Origination Form
Proposed Revisions to a Standard Plans Index

Originator:	Meyer, Ronald and Lemus, Vivian	Index Number:	700-120
Date:	6/22/2026	Sheet Number(s):	1,2,5,6,7
E-mail:	Ronald.Meyer@dot.state.fl.us	Index Title:	ENHANCED HIGHWAY SIGNING ASSEMBLIES

UPDATED Table of Contents

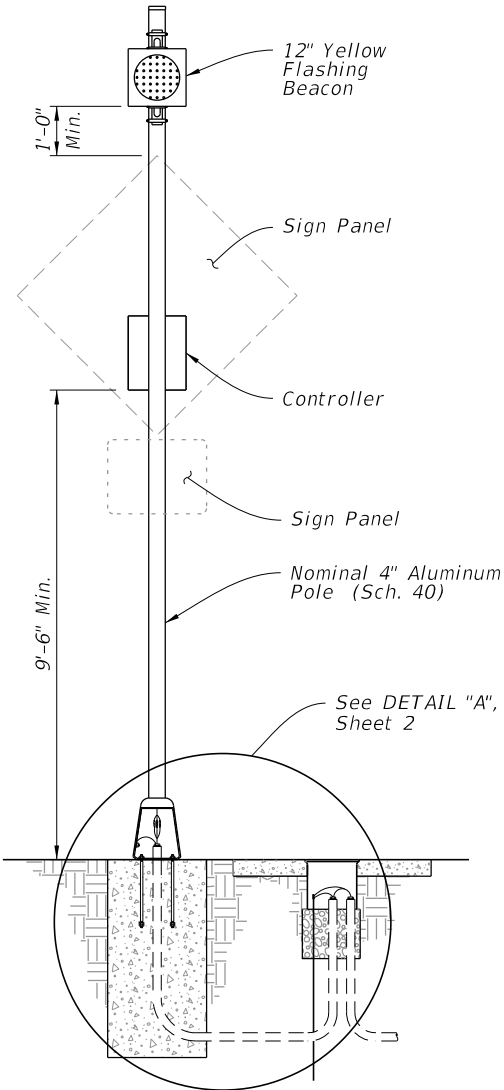
Sheet 1: Updated the Table of Contents.

CONDUIT, WIRING, AND FOUNDATION DETAILS

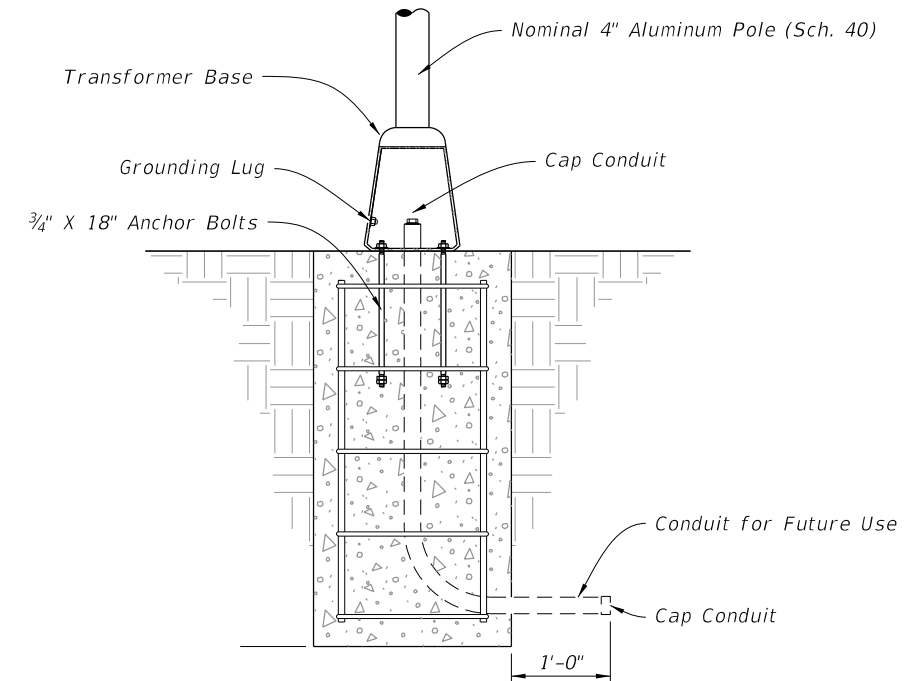
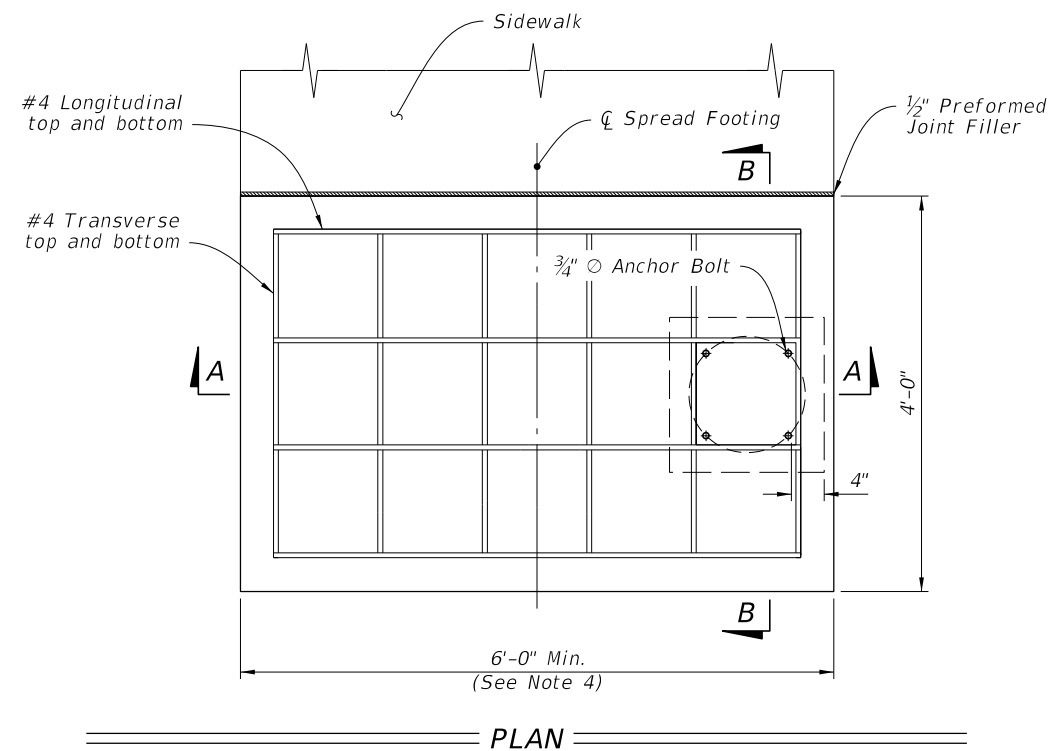
Sheet 2: Updated electrical component in Detail "A"

~~One Pole, Non Fused, Watertight Breakaway Electrical Connectors~~

~~One Pole, Non Fused, Watertight Breakaway Electrical Connectors~~

Sheet 2 - To improve the electrical safety and operational reliability of Enhanced Highway Signing Assemblies. The change reduces the likelihood of energized conductors being exposed after a knockdown event, minimizes equipment damage, and enhances overall system safety.

LAST REVISION		DESCRIPTION:		FDOT		FY 2026-27 STANDARD PLANS		ENHANCED HIGHWAY SIGNING ASSEMBLIES		INDEX	SHEET
11/01/25		11/01/26								700-120	5 of 13

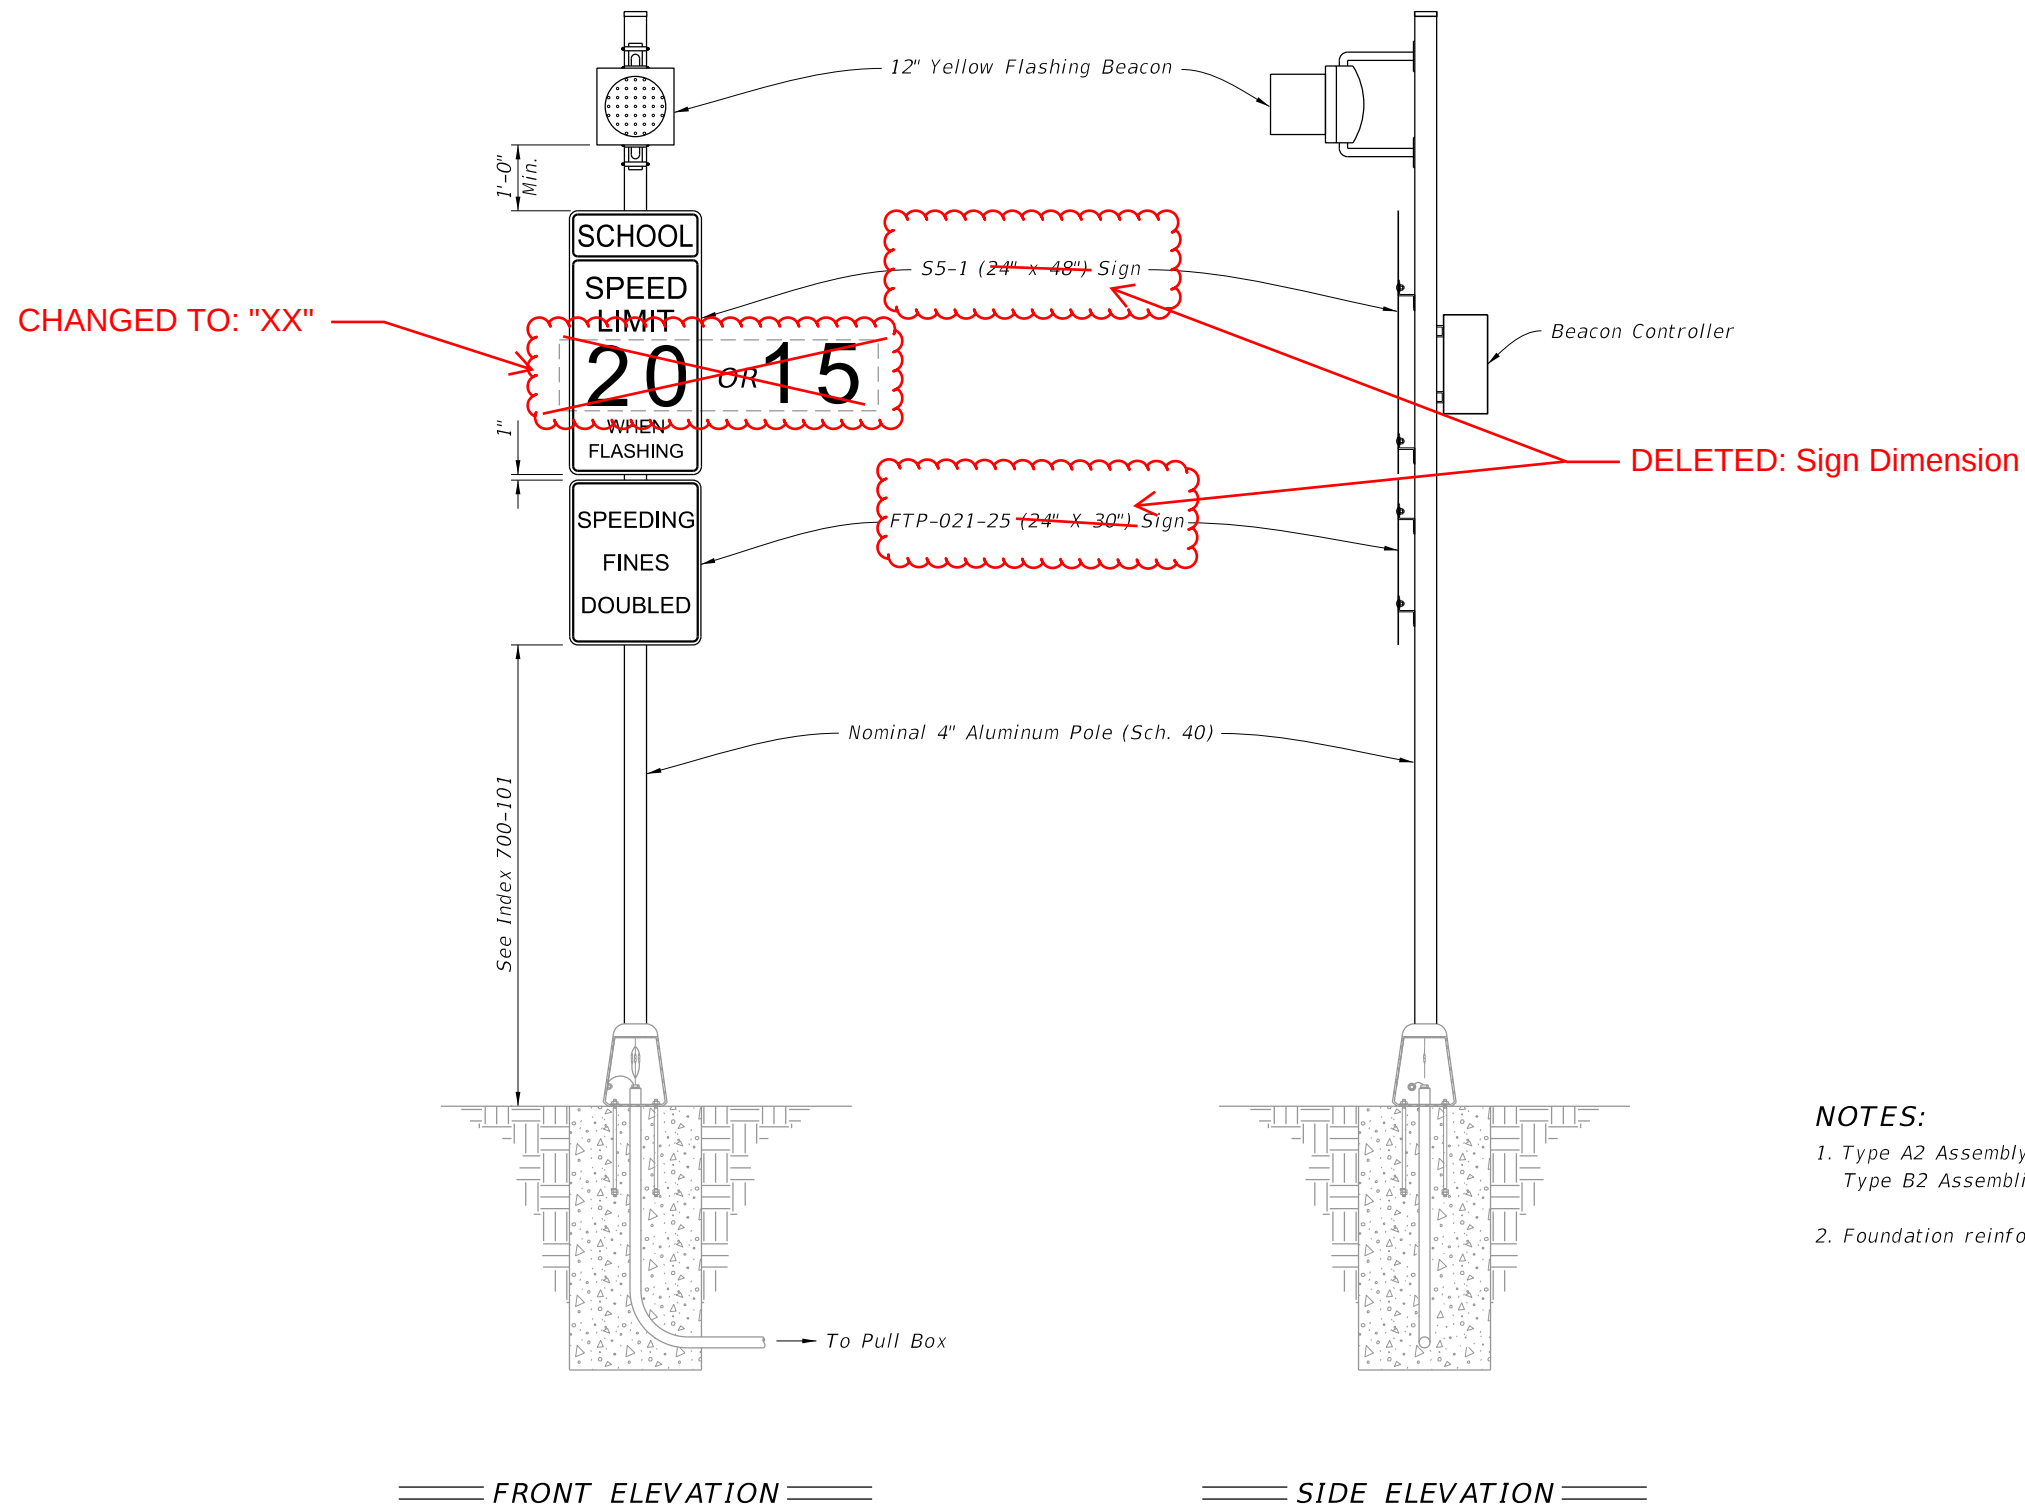
Sheet 5: Deleted dimensions for S5-1 and FTP-021-25; Changed the speed limits from "20 or 15" to "XX" to match figures in upcoming release of Speed Zoning Manual.

Sheet 5 - should be updated to remove specific dimensions for S5-1 and FTP-021-25 and clarify that speed limits can be other than 20 or 15 as appropriate (recommend changing to "XX" to match figures in upcoming release of Speed Zoning Manual); Added Callout "S4-3P Sign".

ROADSIDE SIGN ASSEMBLY-3

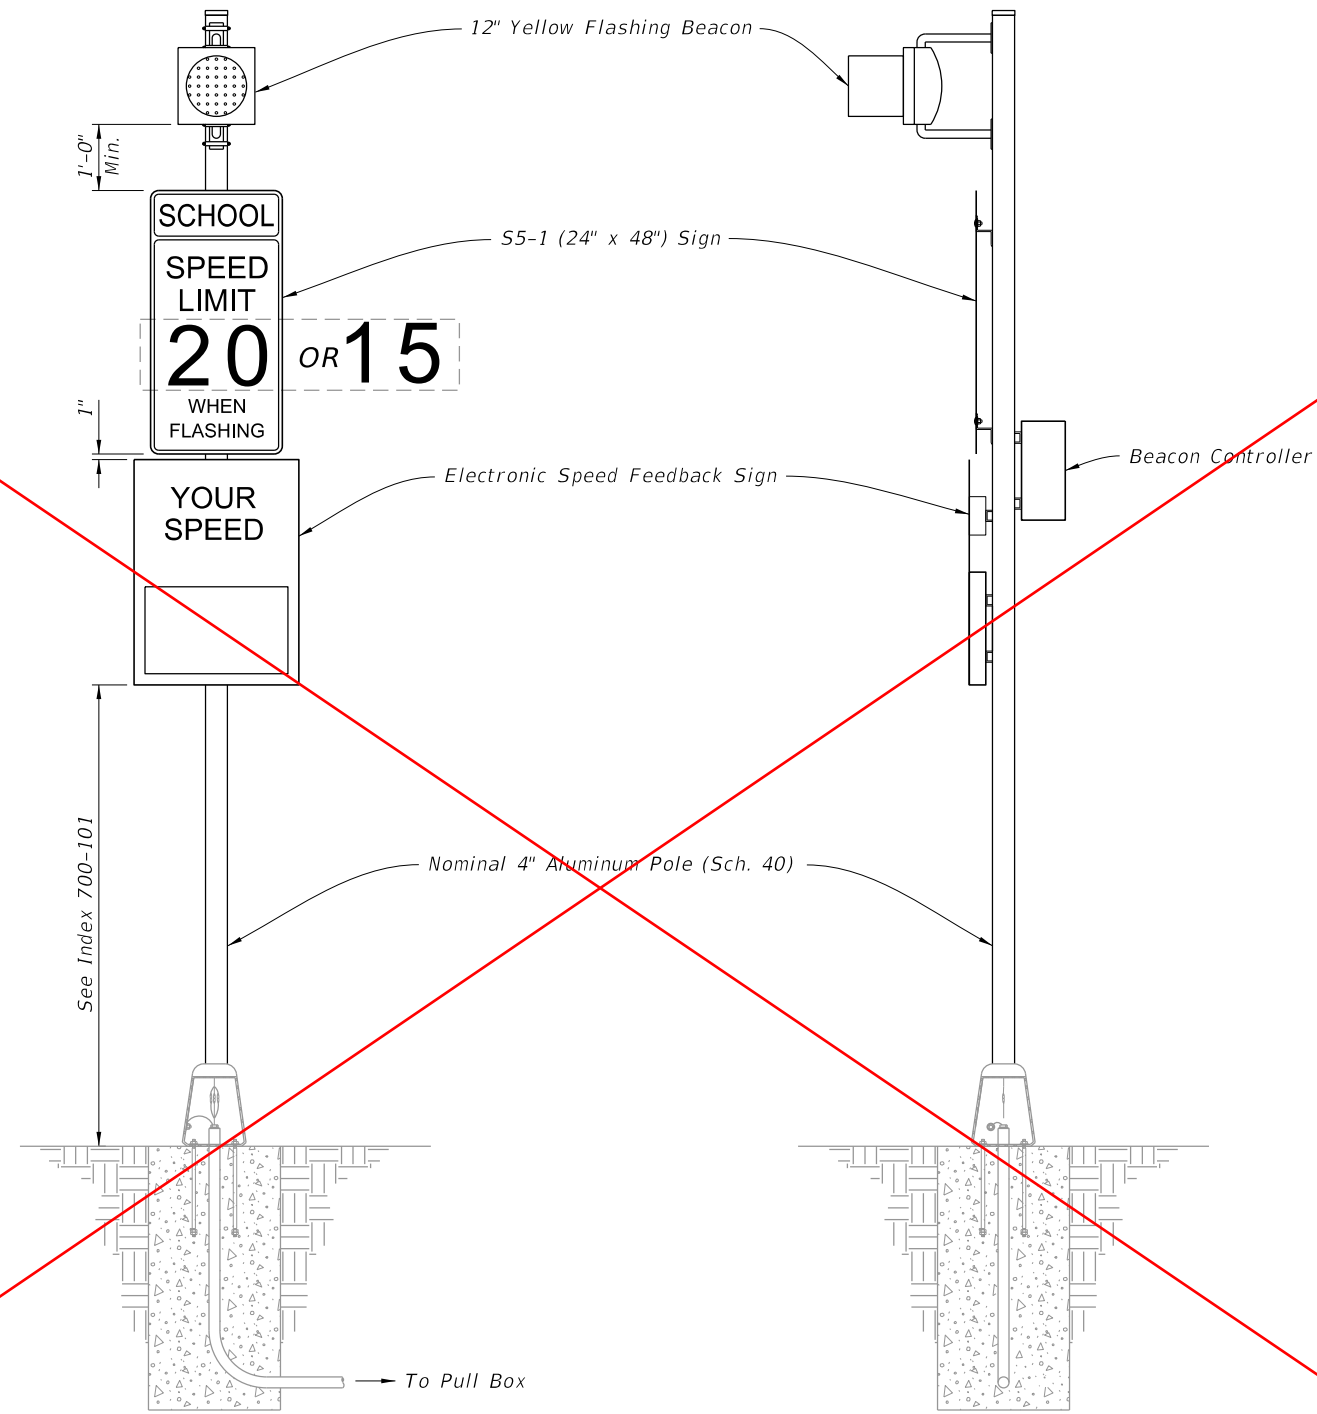
Sheet 6: Deleted Sheet - MUTCD guidance has changed regarding use of speed feedback devices.

DELETED SHEET 6

Sheet 6 - must be deleted because MUTCD guidance has changed regarding use of speed feedback devices. In addition, due to statutory requirements to include a "SPEEDING FINES DOUBLED" plaque (FTP-021-25), there cannot also be a speed feedback device on the assembly. School zone signs with flashing beacons must comply with 700-120, Sheet 5 (i.e., FTP-021-25 mounted directly below the school zone speed limit sign).

ROADSIDE SIGN ASSEMBLY-5

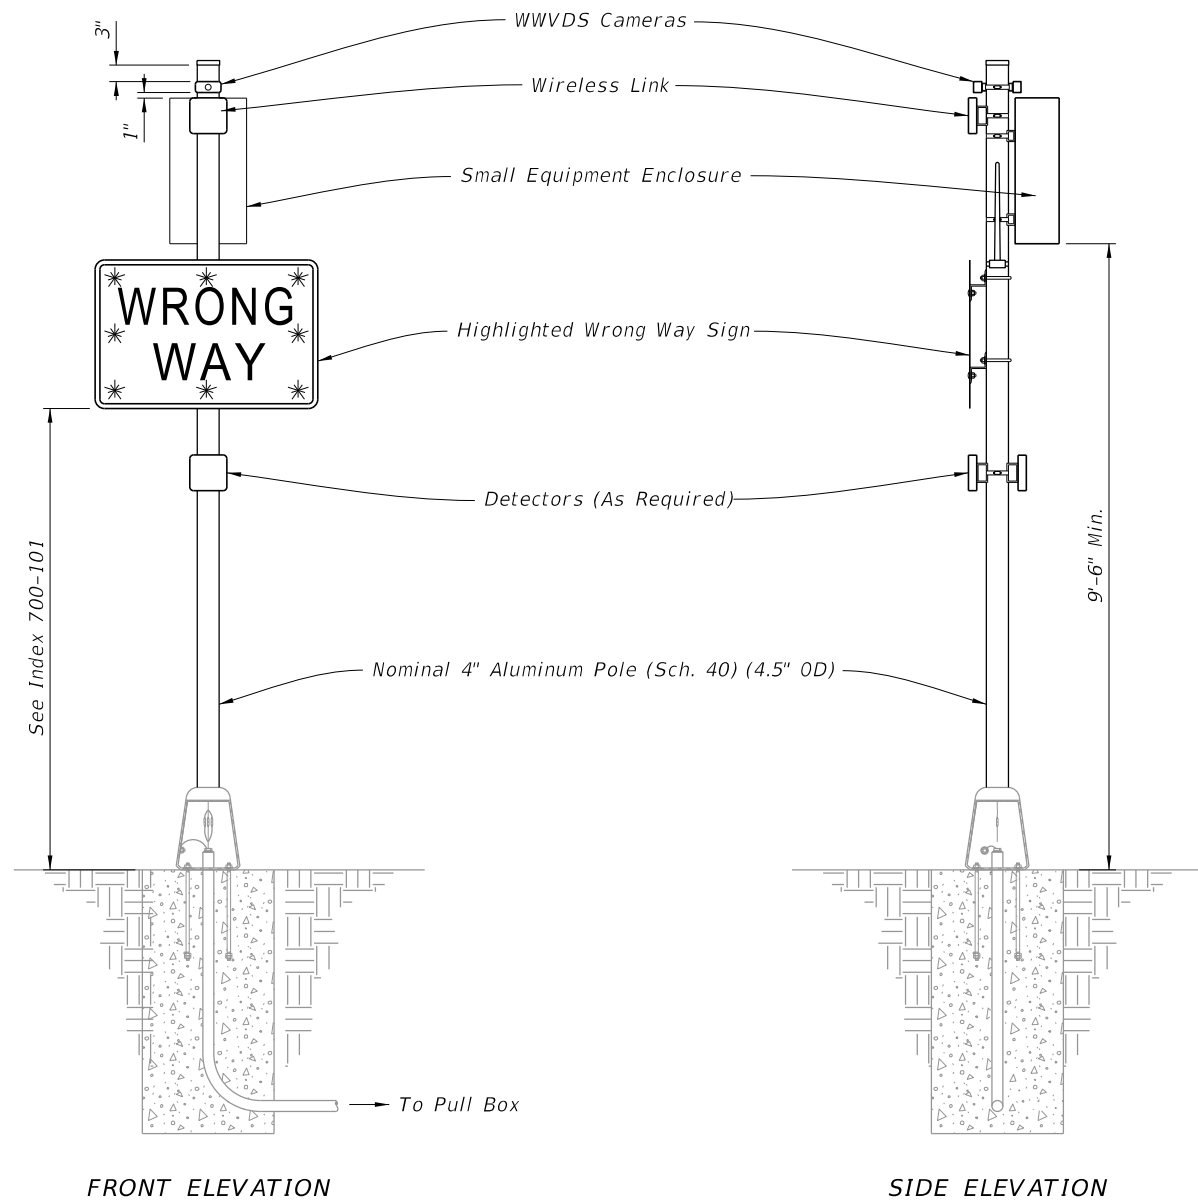
Sheet 7 (New Sheet 6): Added "(As Required)" to the 12" Yellow Flashing Beacon callout; Deleted dimensions for R2-1; Updated the "Electronic Speed Feedback Sign" to "W13-20aP Vehicle Speed Feedback Plaque; Updated the "Your Speed" sign to match the shape and size of the W13-20aP Vehicle Speed Feedback plaque as required and shown in the latest MUTCD; Changed Note 2 - "Install the Vehicle Speed Feedback Plaque in accordance with Specification 700 and 995".

Sheet 7 - (New Sheet 6) must be updated to better match the shape and size of the W13-20aP plaque as required and shown in the latest MUTCD. The TERL has been in contact with speed feedback sign vendors listed on the APL regarding both standalone signs and plaques. Vendors are aware of the MUTCD changes and their need to comply with MUTCD requirements to have products listed on the APL. Note 2 - reflect the reference to SHS and MUTCD
